MFN No. 090-94
Docket No. STN 52-004

**Subject: NRC Requests for Additional Information (RAIs) on the
Simplified Boiling Water Reactor (SBWR) Design**

Attachment 1, "Responses to NRC RAIs"

Figure 5.2-1 Safety/Relief Valve Schematic Elevation

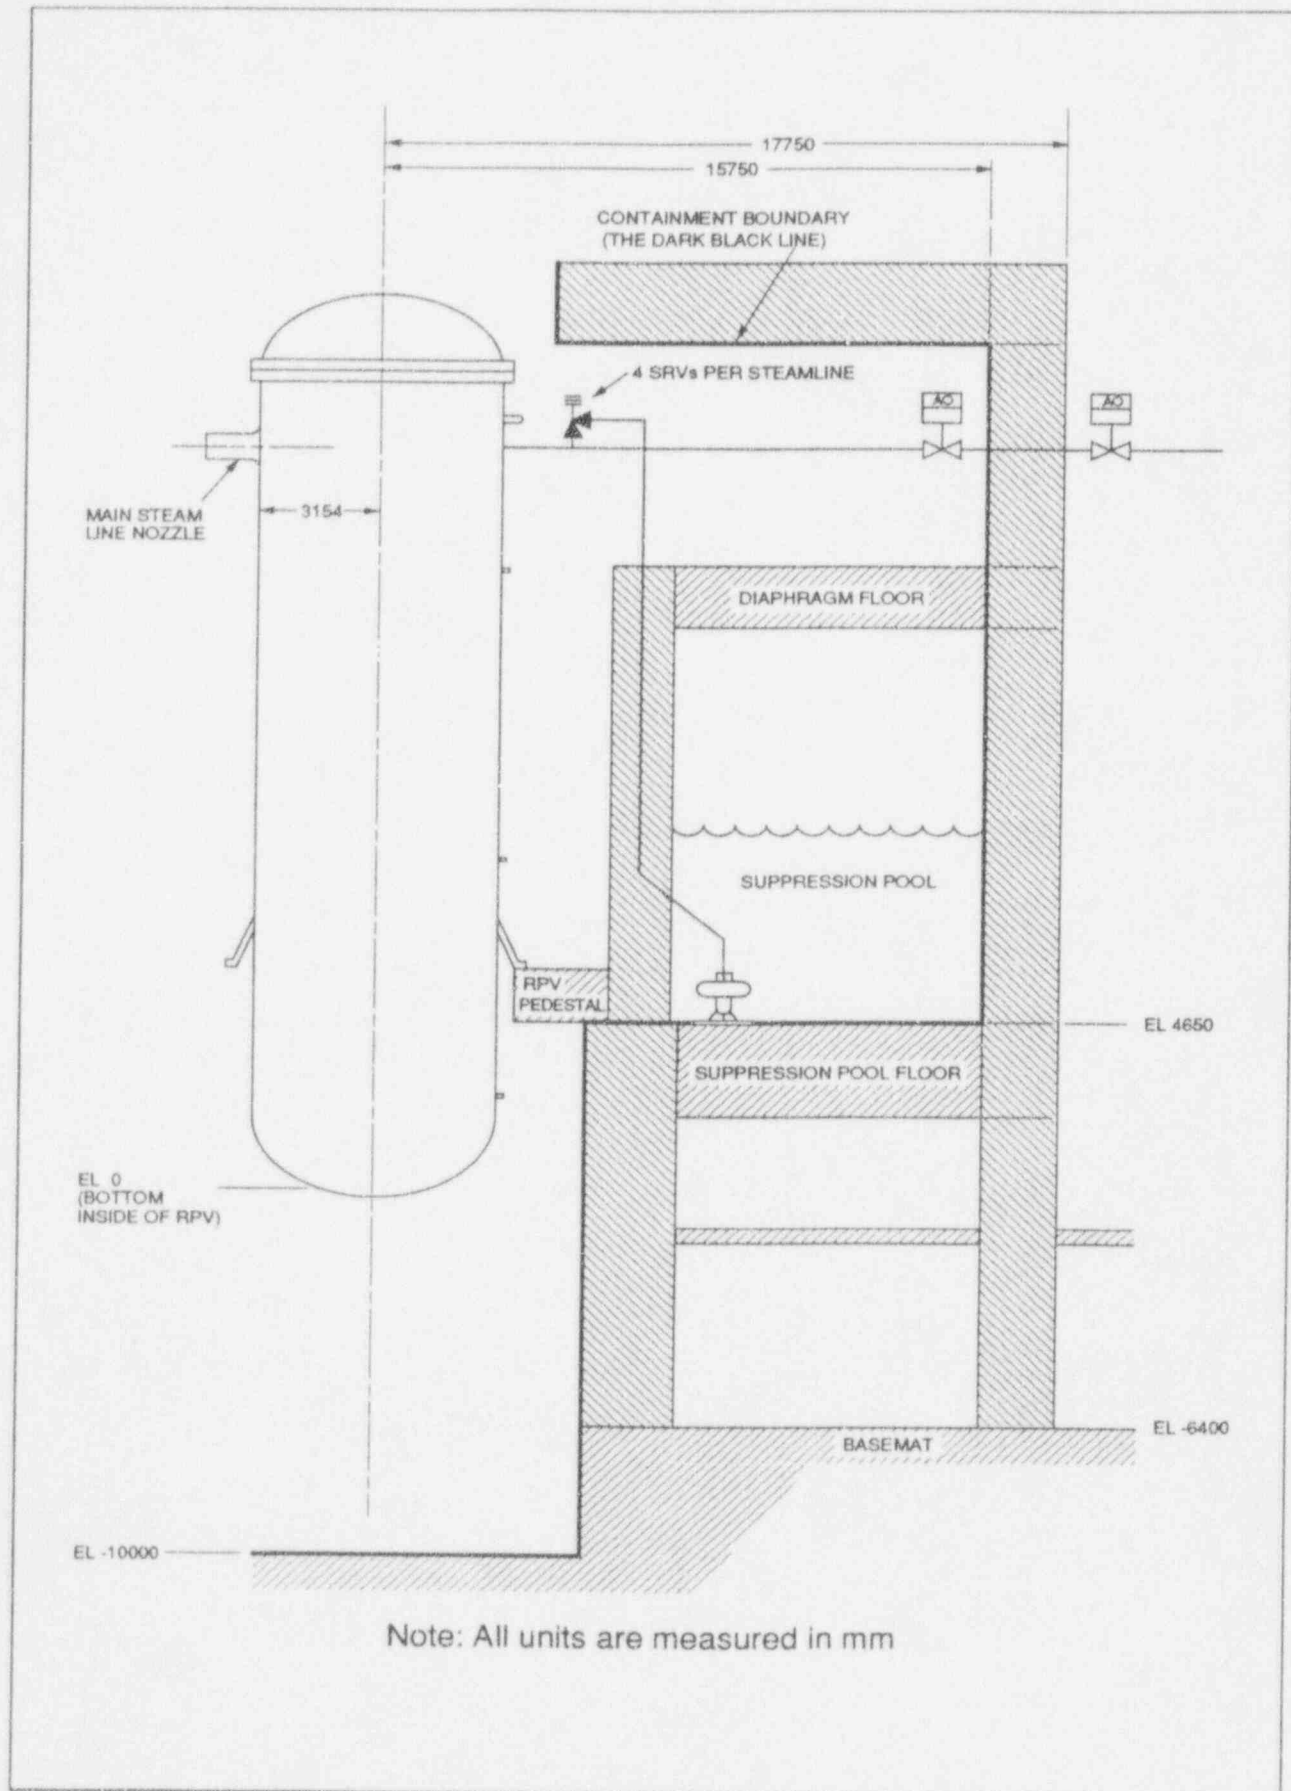
In SSAR Figure 5.2-1, add units to all the numerical values shown in the figure.

All units of numeric values in Figure 5.2-1 are mm and there is a note to that effect on the attached revised figure.

The process flow diagram 107E6073 Rev. 1 is attached.

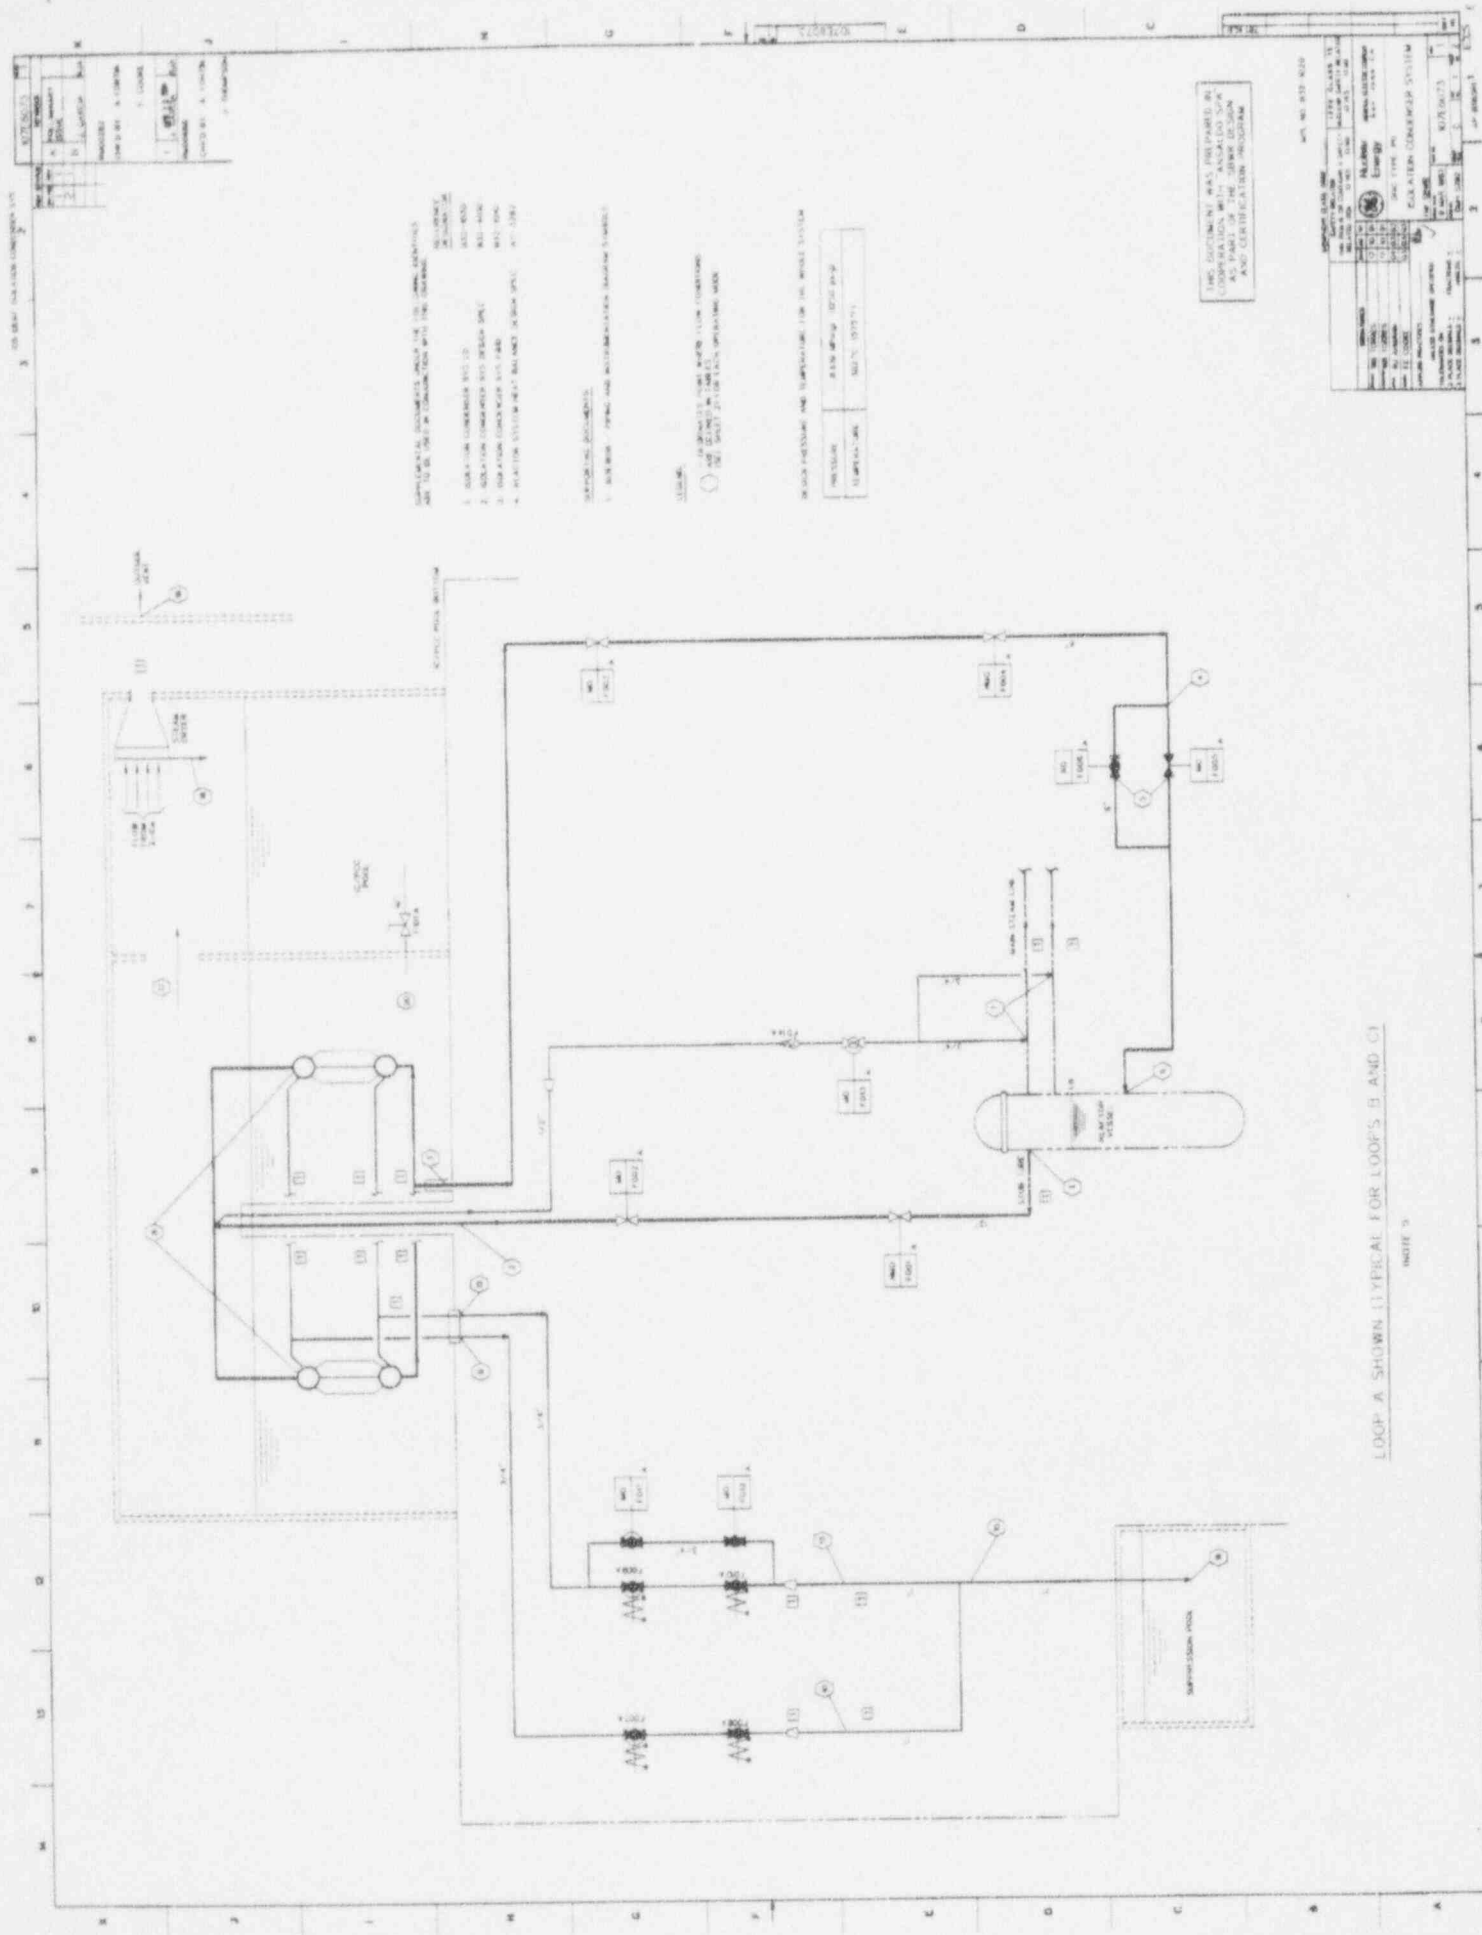
Provide a diagram showing the isolation condenser system (ICS) design parameters: Pressures, temperature, and flow rates. Submit the process flow diagram for the ICS.

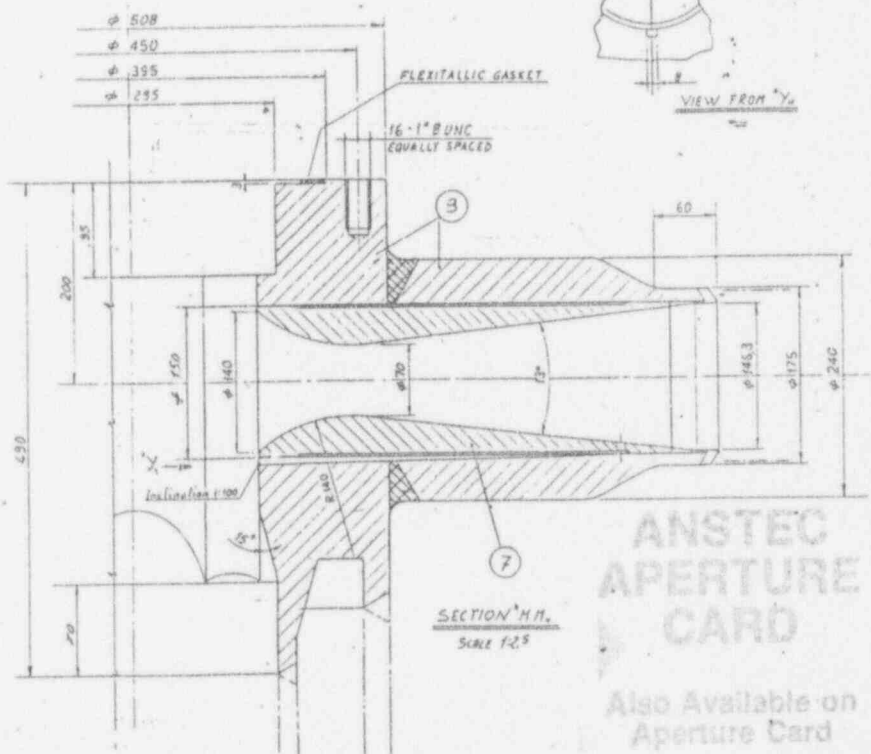
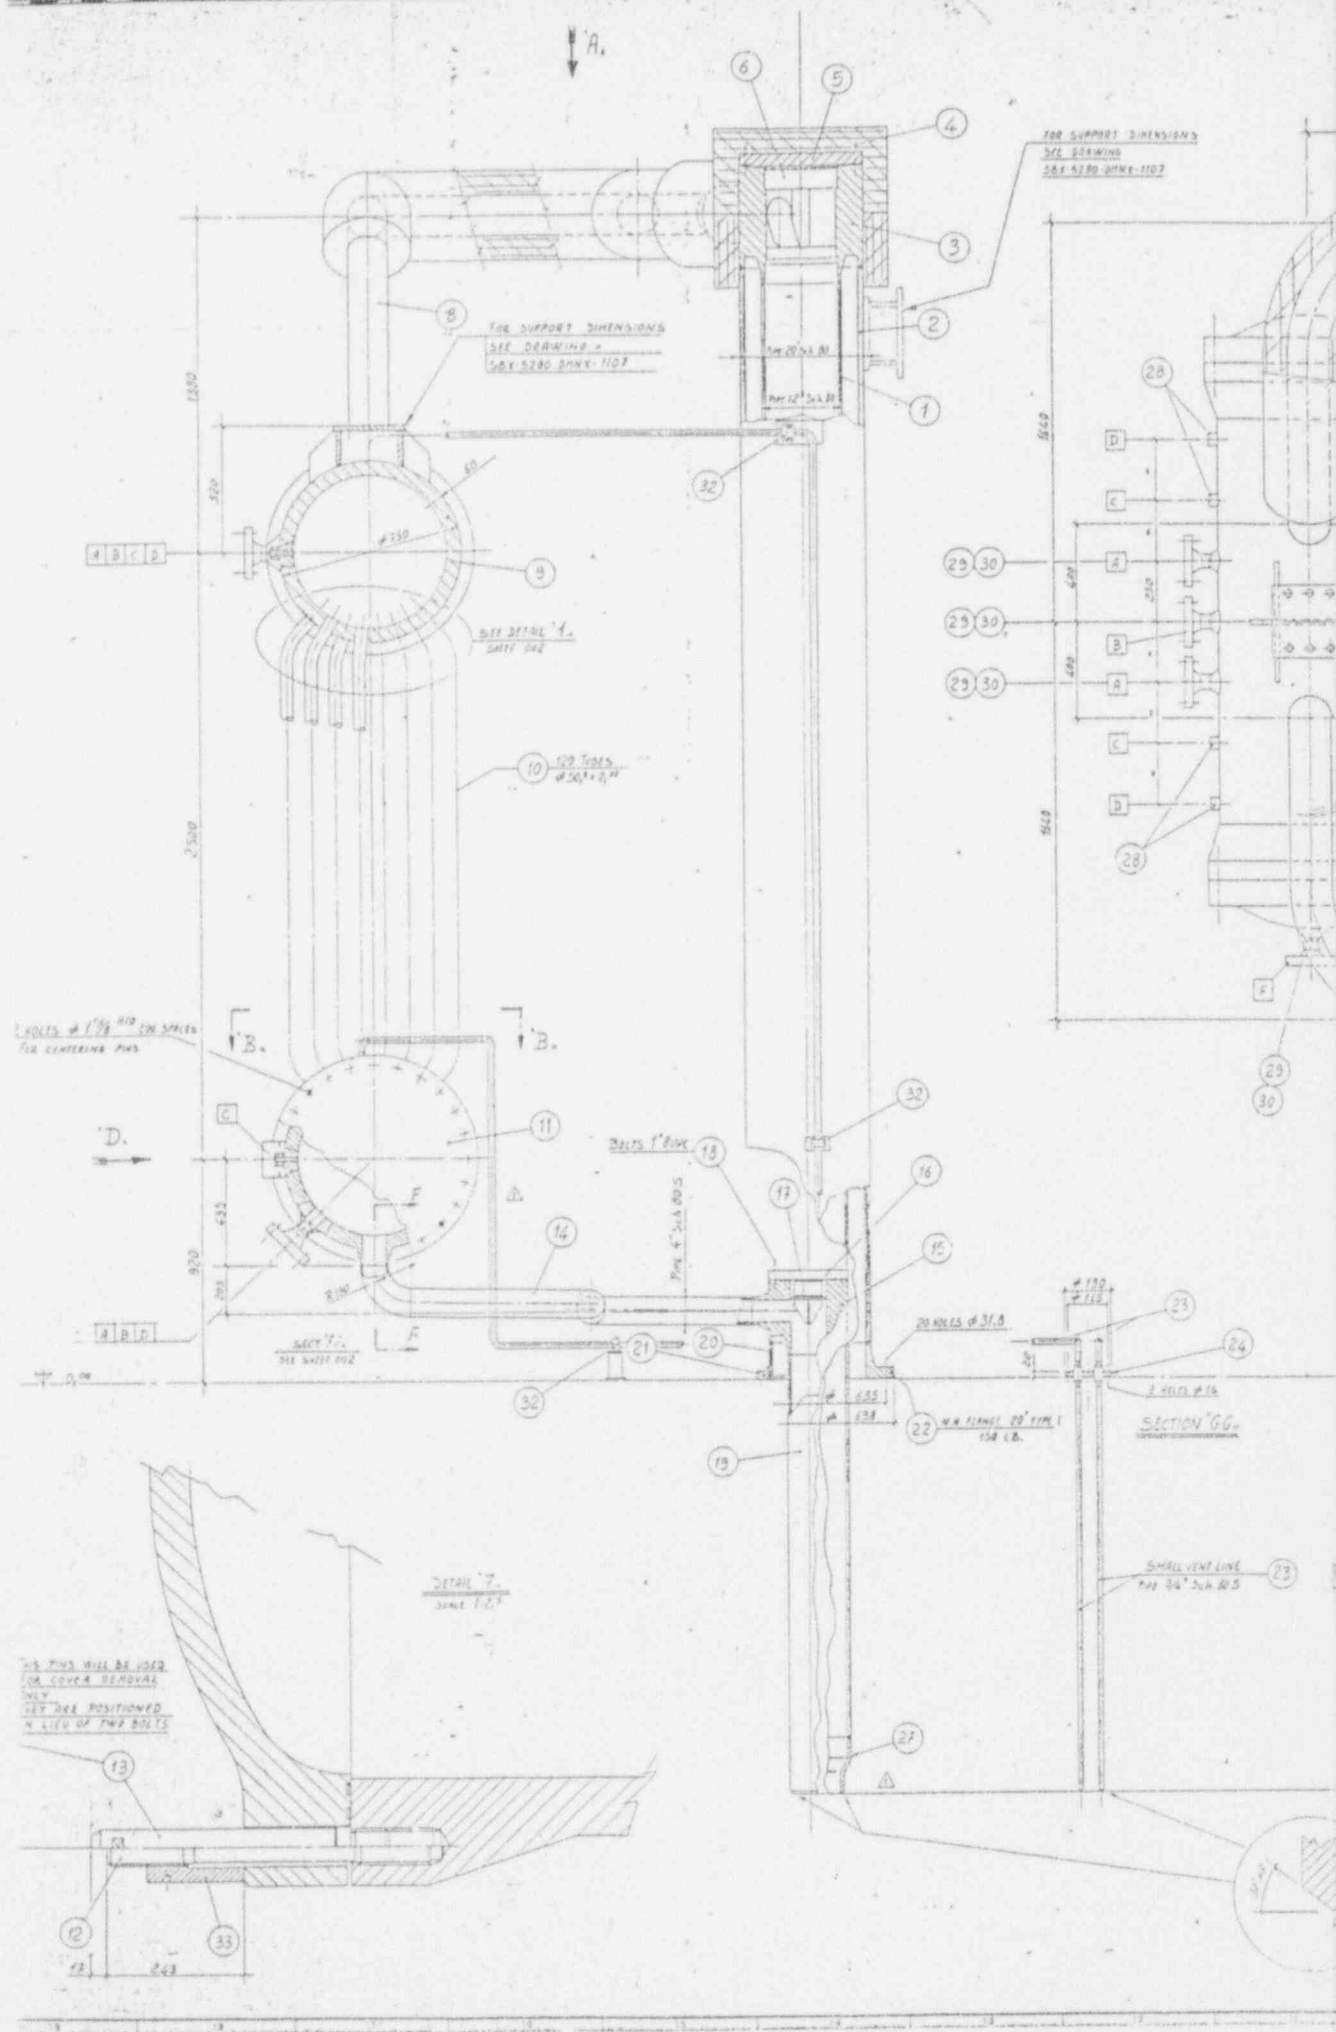
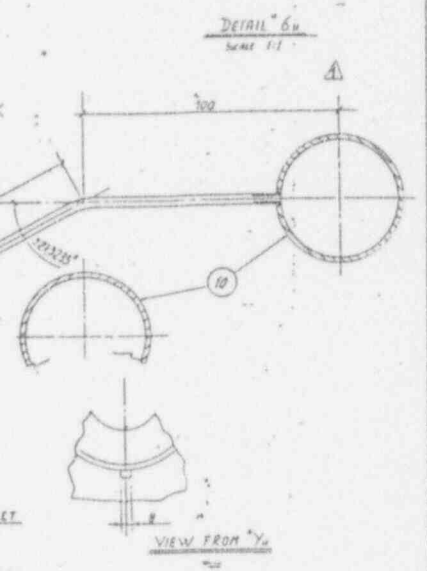
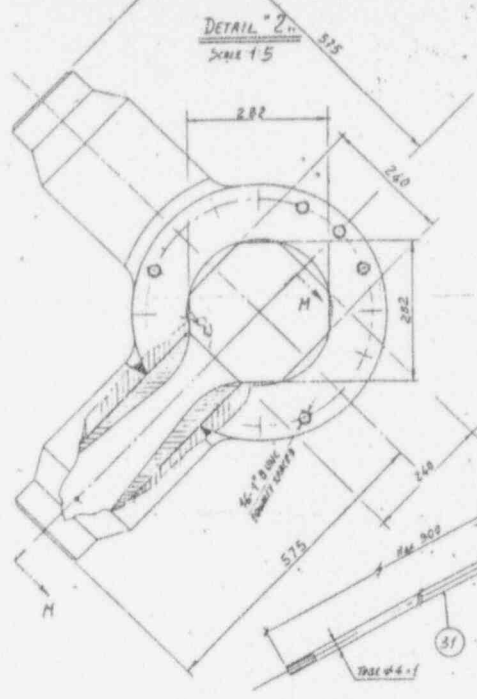
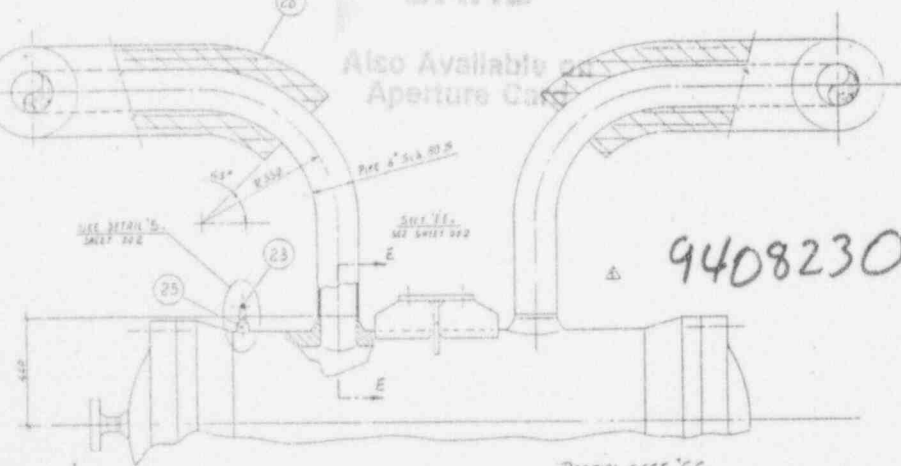
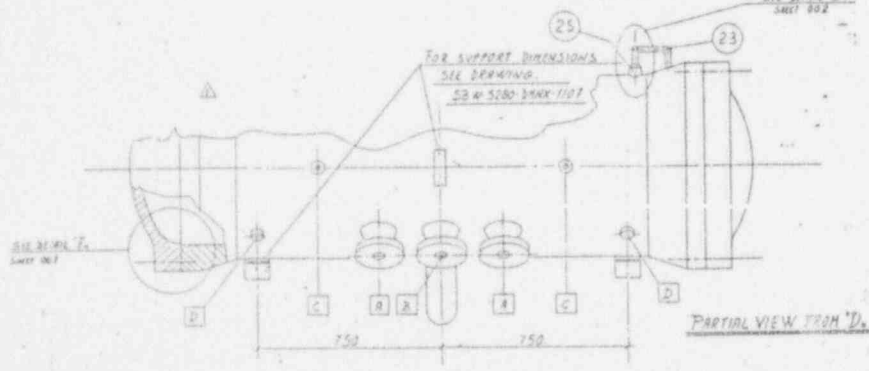
The isolation condenser for the SBWR is a vertical heat exchanger which is significantly different from the IC in operating plants. Provide a detailed description and drawing of the SBWR IC.

The Isolation Condenser System (ICS) specification 25A5013 Rev. 1 (attached) contains a detailed description of the isolation condenser system. A copy of the Isolation Condenser (IC) drawing is attached.
